METRO PLANNING COMMITTEE OF THE TOWN PLANNING BOARD

MPC Paper No. 3/19

**Submission for Compliance with
Approval Condition (j) of Application No. A/H4/94**

**Proposed Alteration and Modification Works to the Building
and External Façade for Cultural/Leisure/Retail/Food &
Beverage Uses/Open Space/Ancillary Support, for the Central Market
Revitalization Project in “Other Specified Uses” annotated
“Building with Historical and Architectural Interests Preserved for
Commercial, Cultural and/or Community Uses” Zone,
The Former Central Market, 80 Des Voeux Road Central, Central, Hong Kong**

參考編號 REFERENCE No. A/H4/94	繪圖 DRAWING AA - 7
----------------------------------	-------------------------

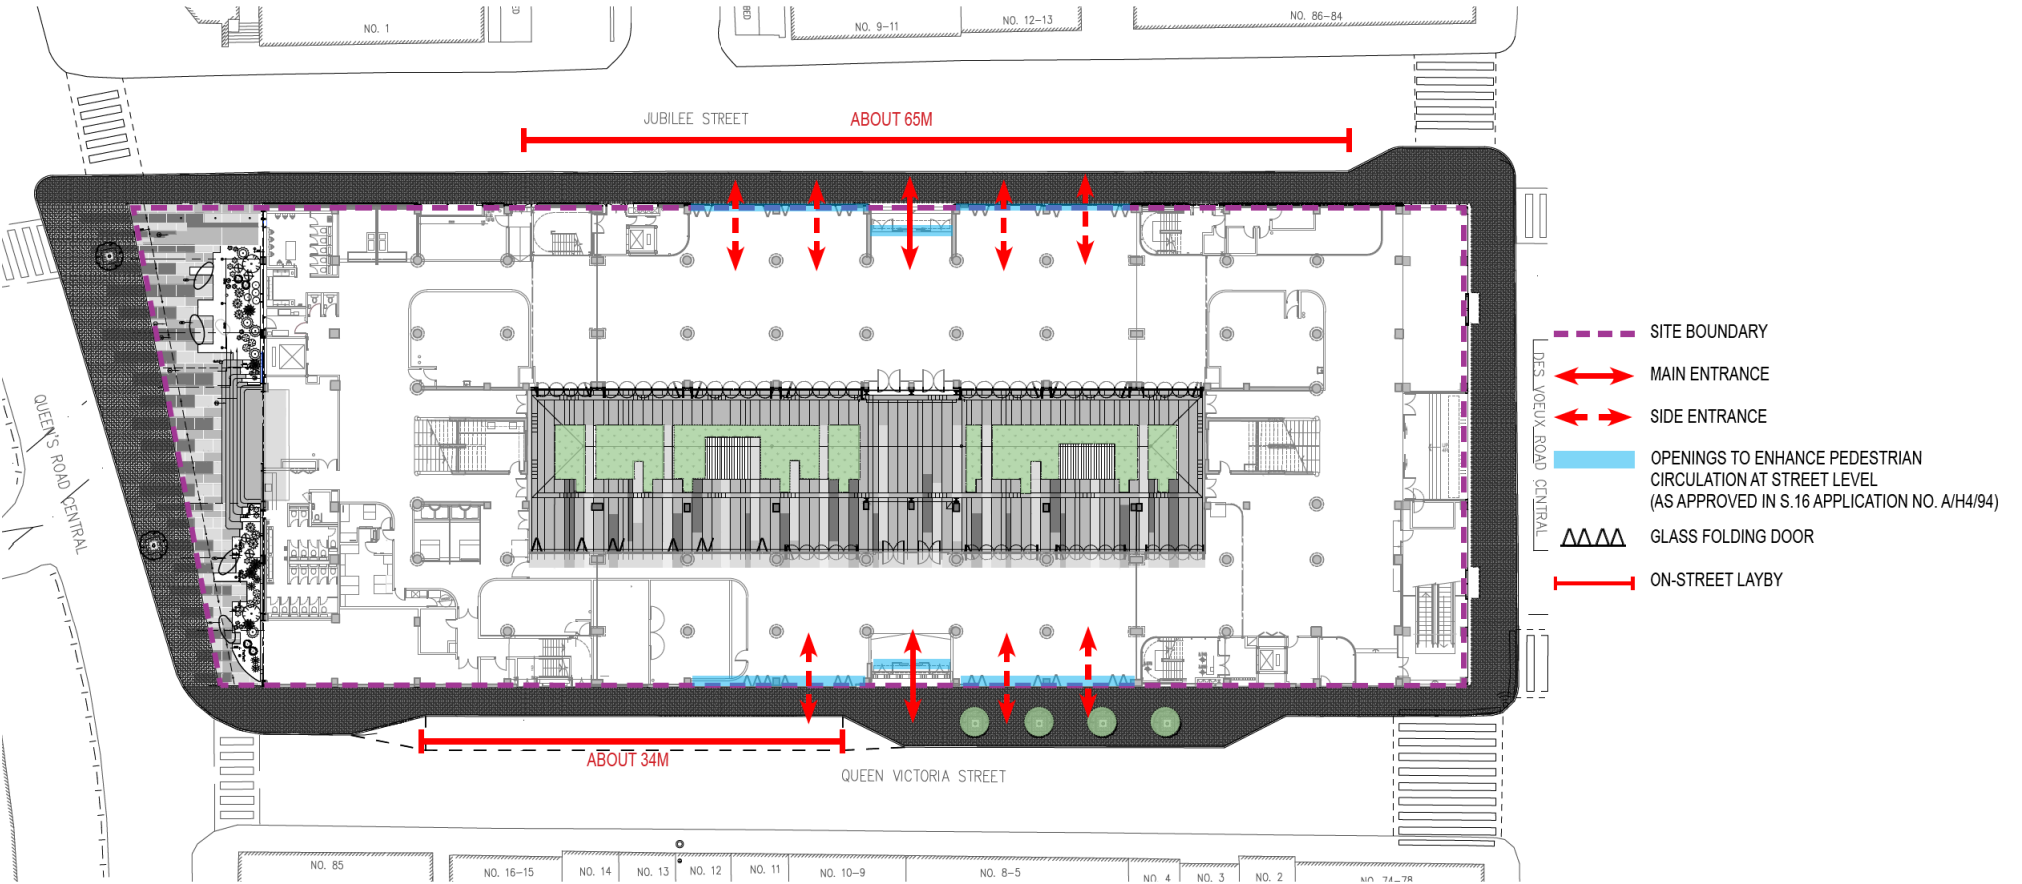
- 3.4 The widened pedestrian pavement complemented by tree plantings along Queen Victoria Street and the widened entrances along both Queen Victoria Street and Jubilee Street (**Drawings AA-6 and AA-7**) would create a more comfortable pedestrian environment.

FIGURE 2.1

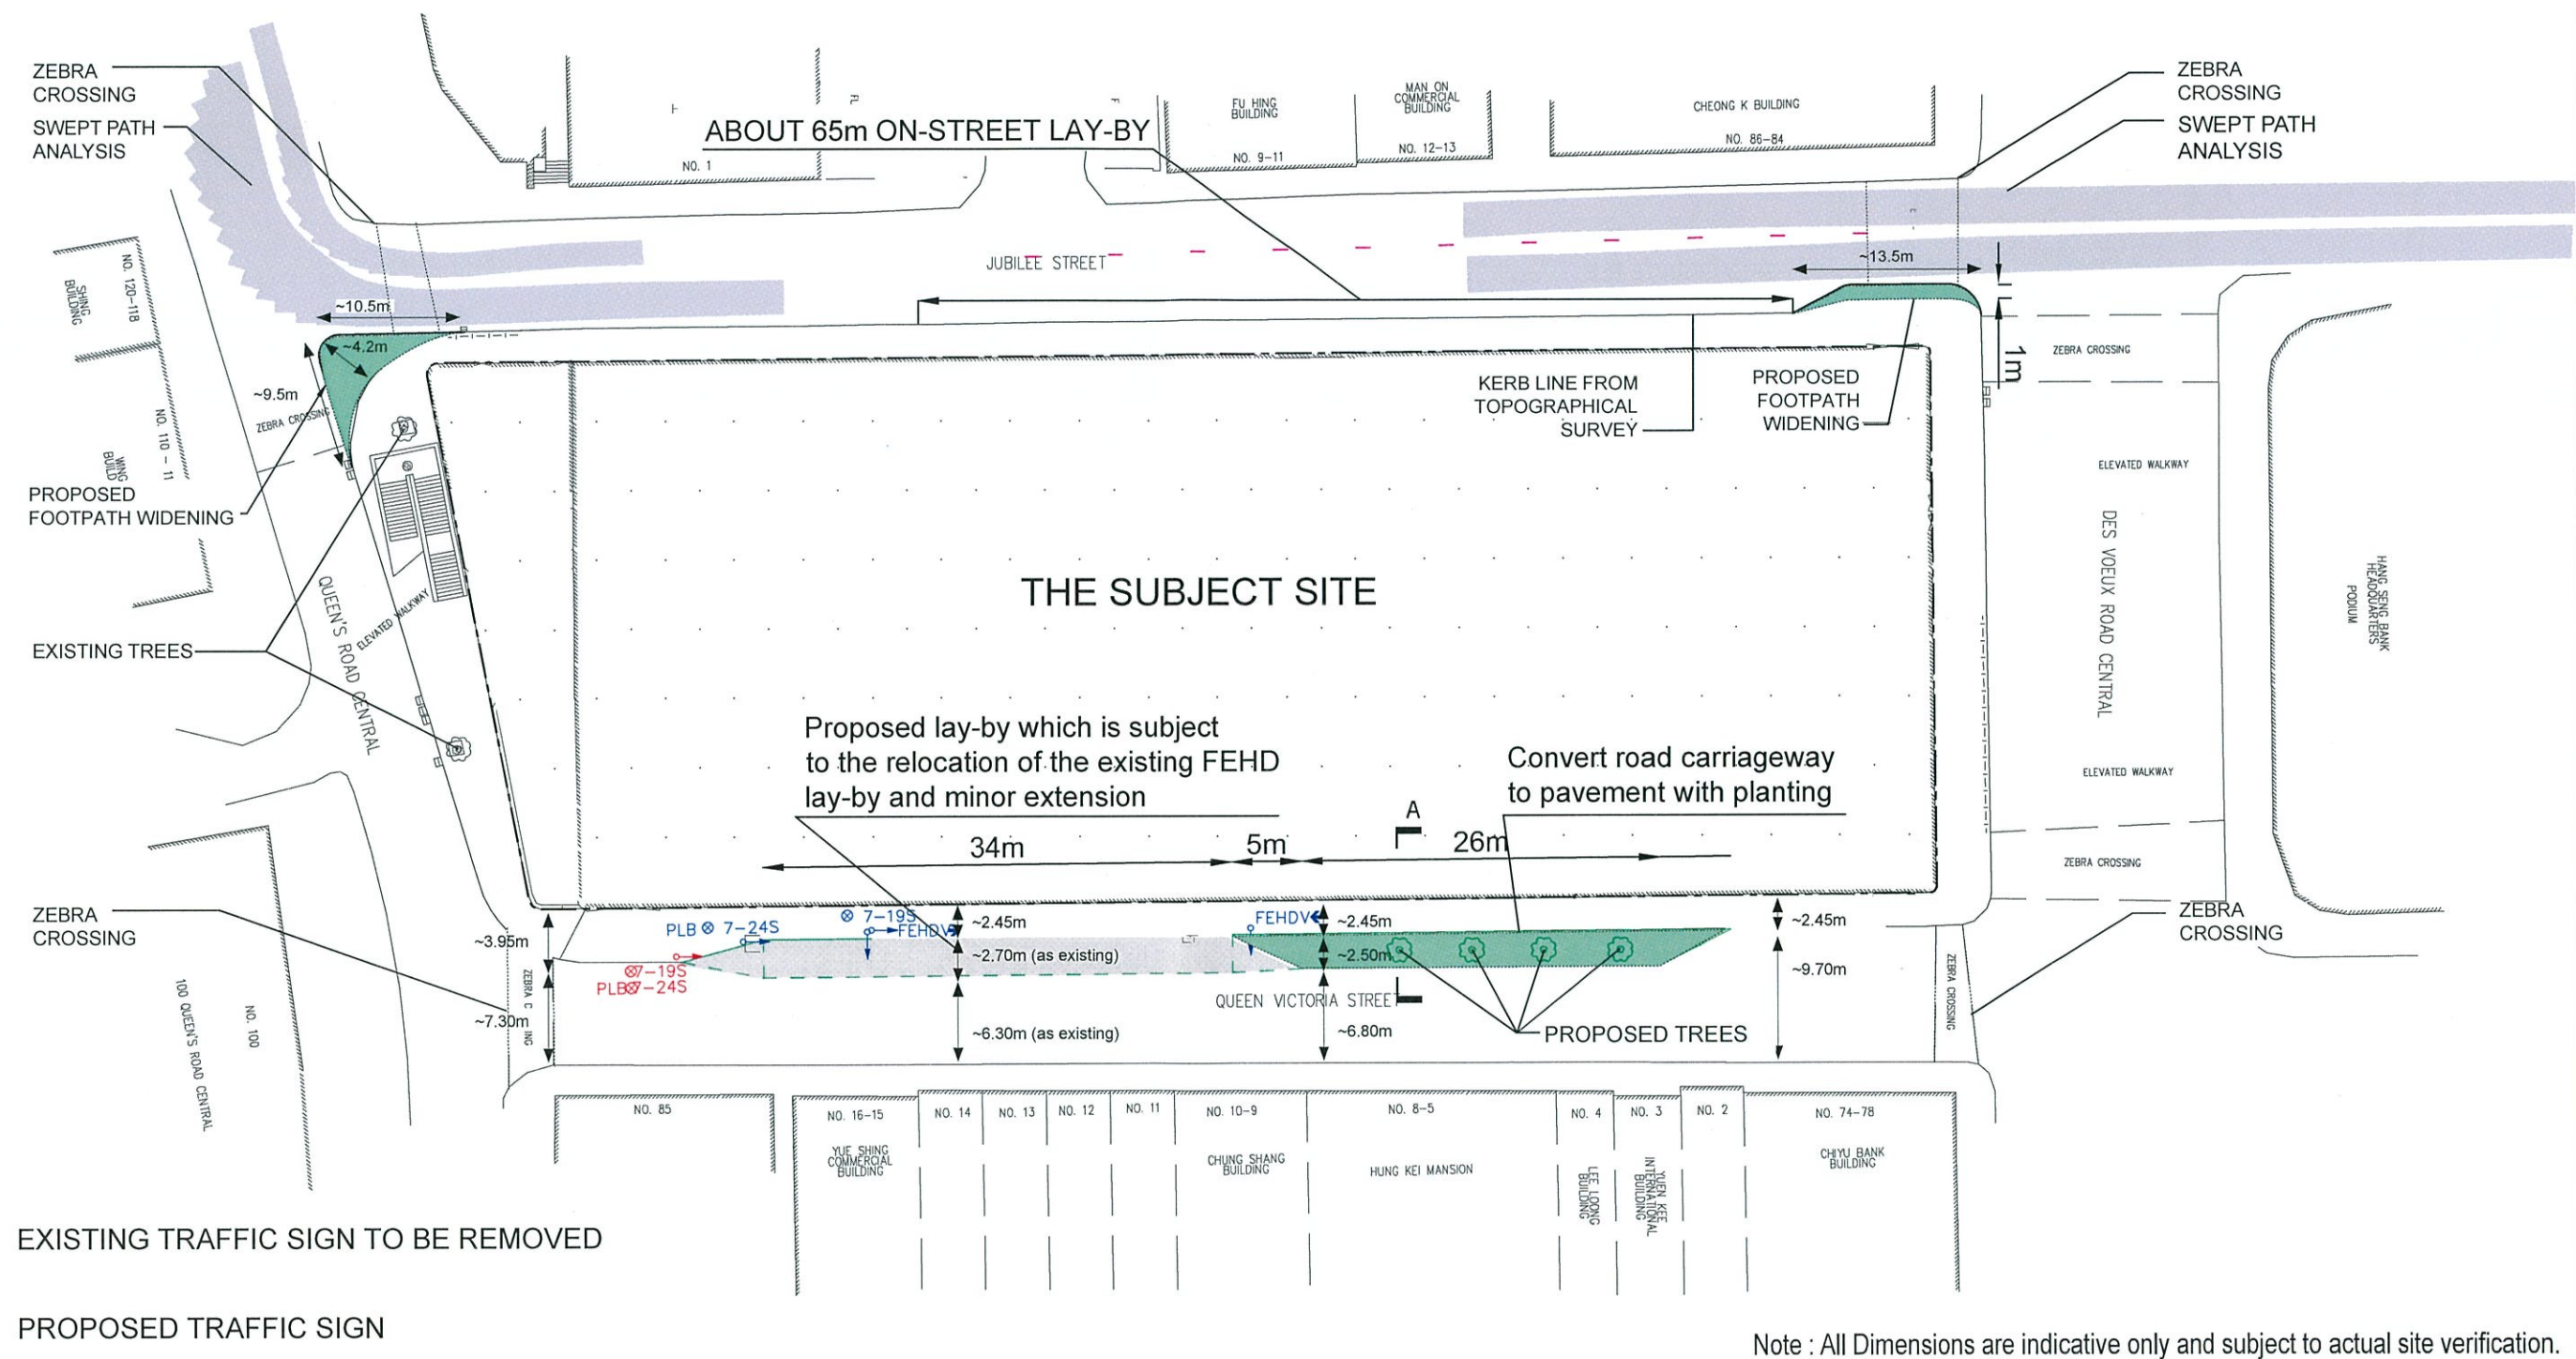
- 2.1.1 The area shown coloured green on **Figure 2.1** is proposed to be widened to enhance pedestrian environment. The associated traffic signs and road marking shall be provided and the obsolete traffic signs are removed.
- 2.1.2 The existing 28m FEHD lay-bys on Queen Victoria Street would be relocated to provide space for on-street lay-by for loading/unloading. FEHD lay-bys will be re-provided at Eastern Street North (21M) and Pier Road (7m) respectively (refer to **Appendix D** for details). The length of the on street lay-by is proposed to further extend 6m to about 34m by modifying the kerblines as per **Figure 2.1**.

FIGURE 2.2

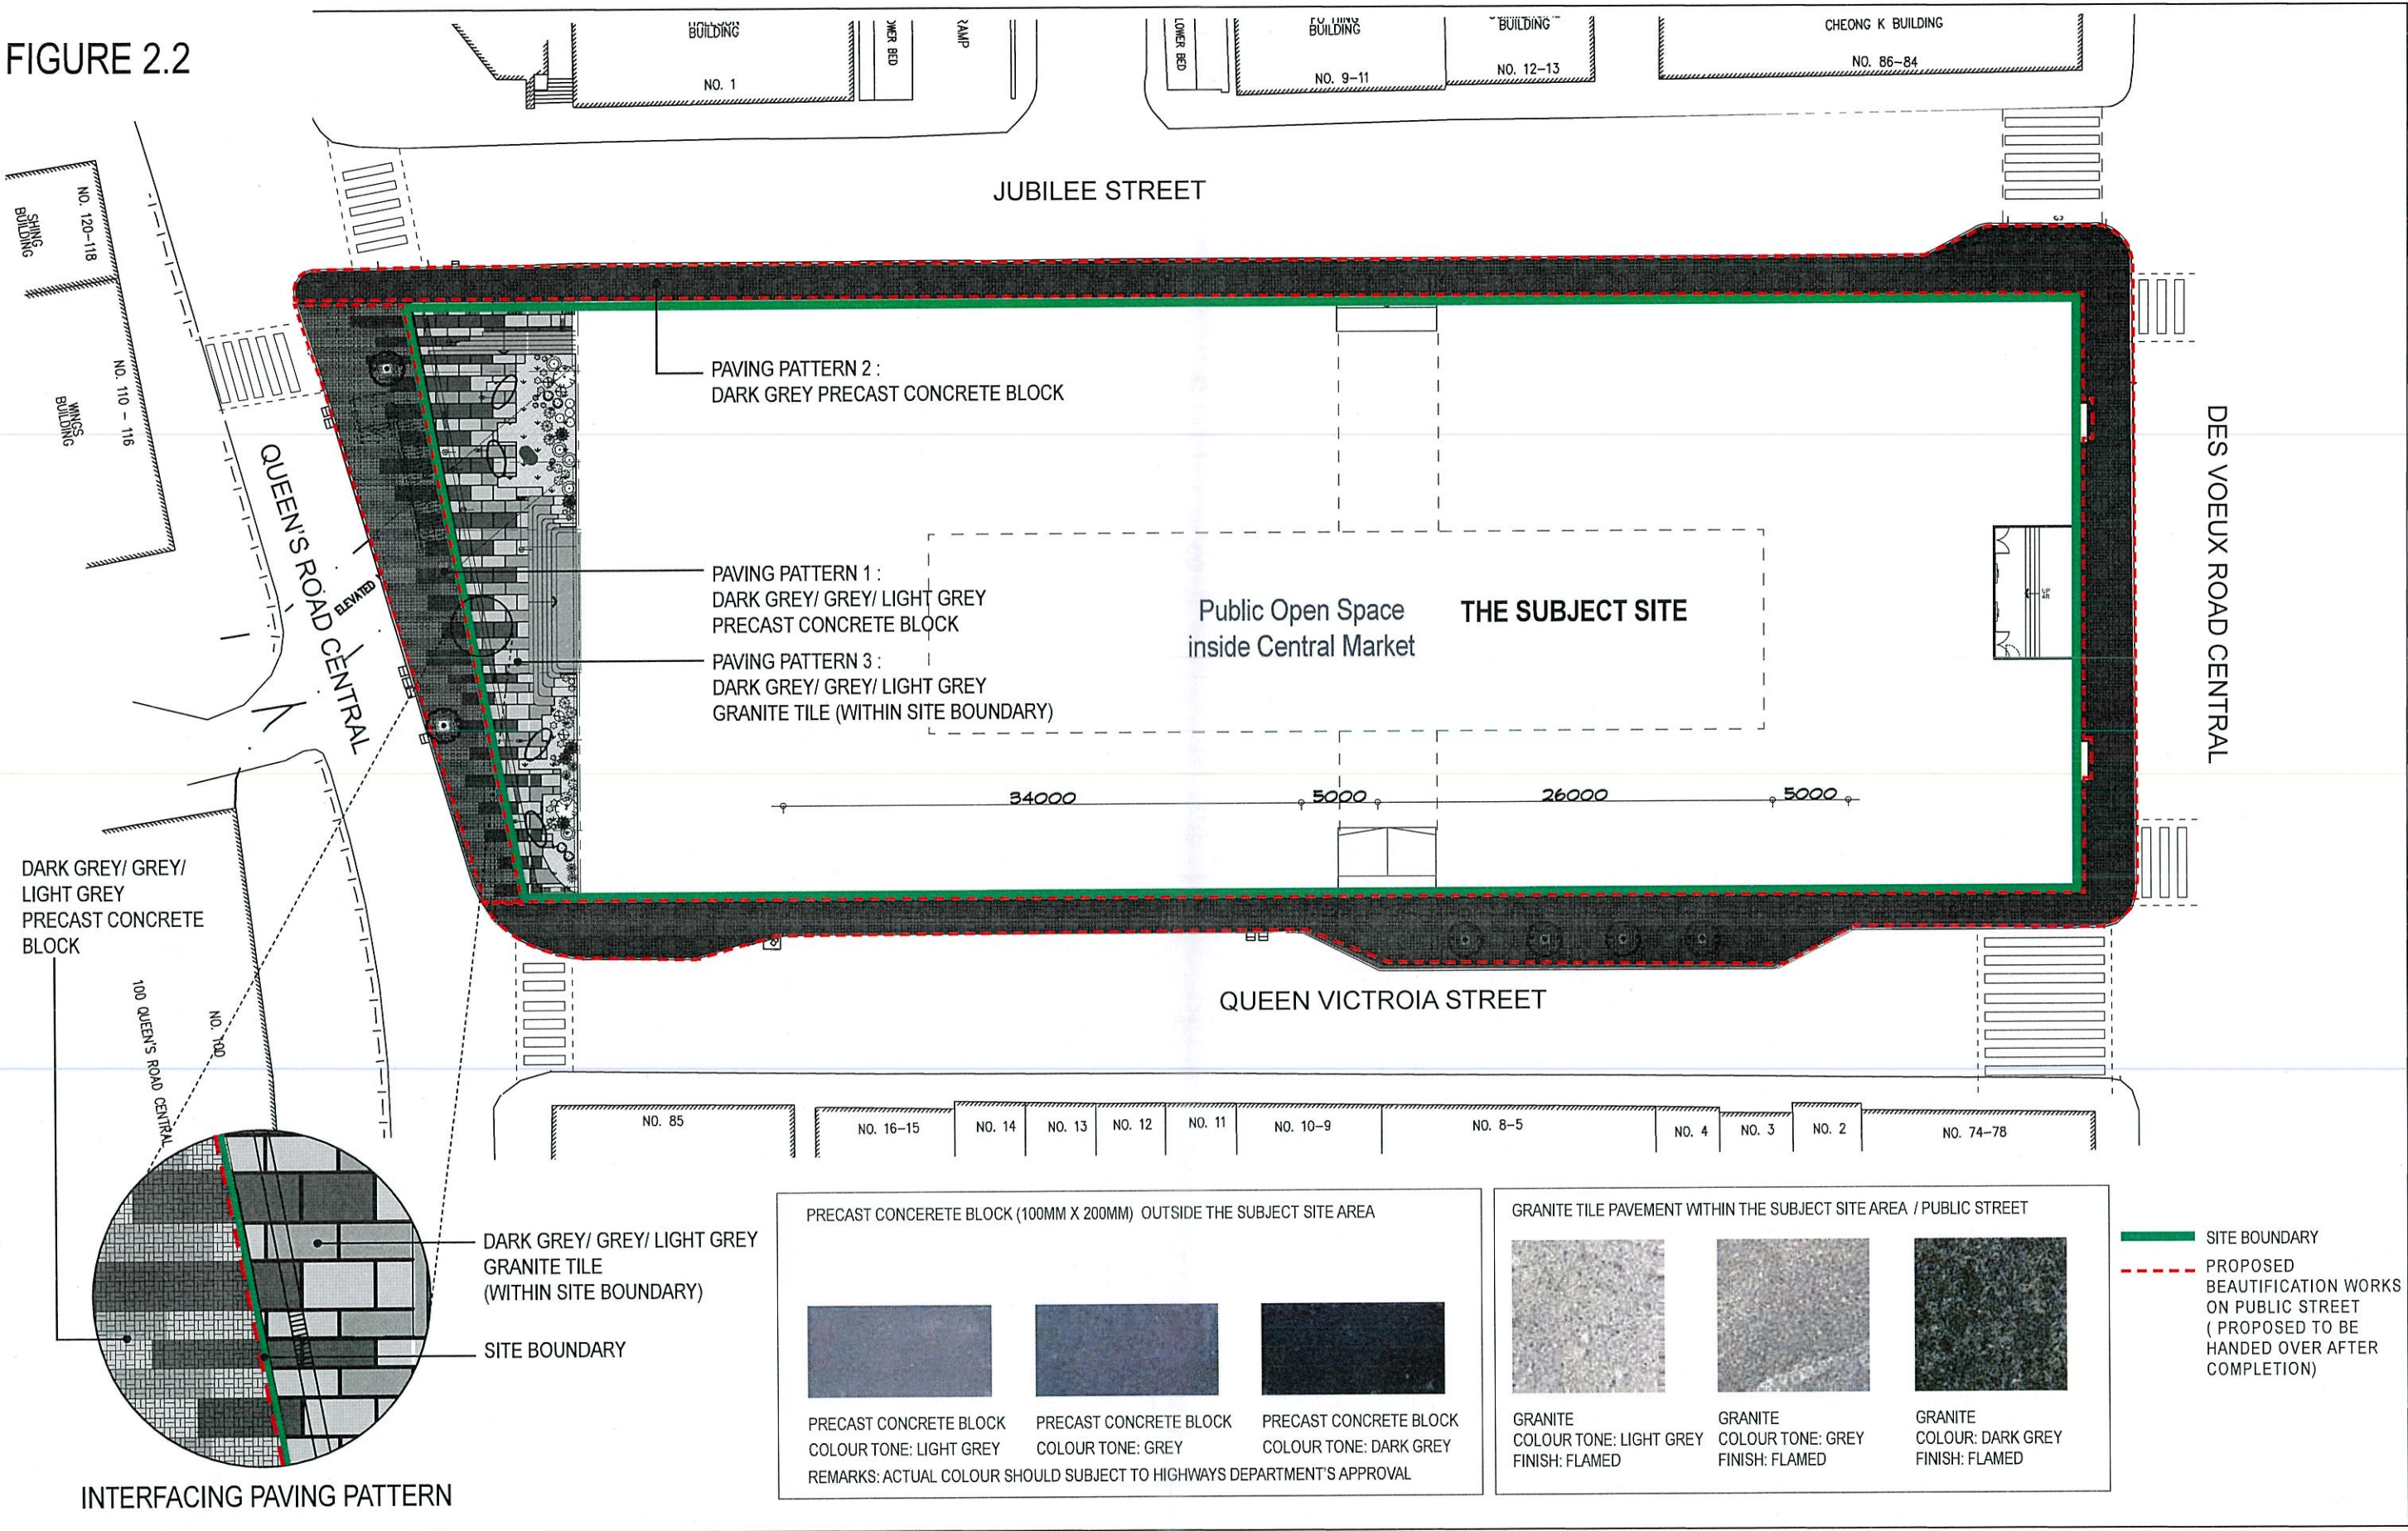
(ii) Please note that precast concrete paving blocks had been adopted at the footpath in the vicinity of the Central Market at Queen Victoria Street, Des Voeux Road Central, Queen’s Road Central and Jubilee Street. Please review the paving materials and pattern at footpath surrounding the site taking into account the existing pedestrian pavement design at Queen Victoria Street, Des Voeux Road Central, Queen’s Road Central and Jubilee Street in the vicinity of the site.	(ii) Granite blocks (similar to the proposed pavement material) were used on Queens Road Central (QRC) (see Figure A3). As part of the place making initiative, the same pattern and material of the entrance plaza facing QRC approved on 23.11.2016 was applied at the pavement area surrounding Central Market to ensure design consistency to strengthen the local identity and create a better streetscape and comfortable pedestrian environment.

- 2.3.1 The pedestrian pavement surrounding Central Market site is proposed to be paved in concrete paver block in accordance with HyD standard.
- 2.3.2 The paving pattern, materials and details is designed to be consistent to the approved landscape proposal within the site. The building is highlighted by the colour tone of pavement proposed, which creates contrast with the building façade. (refer to **Figure 2.2**).
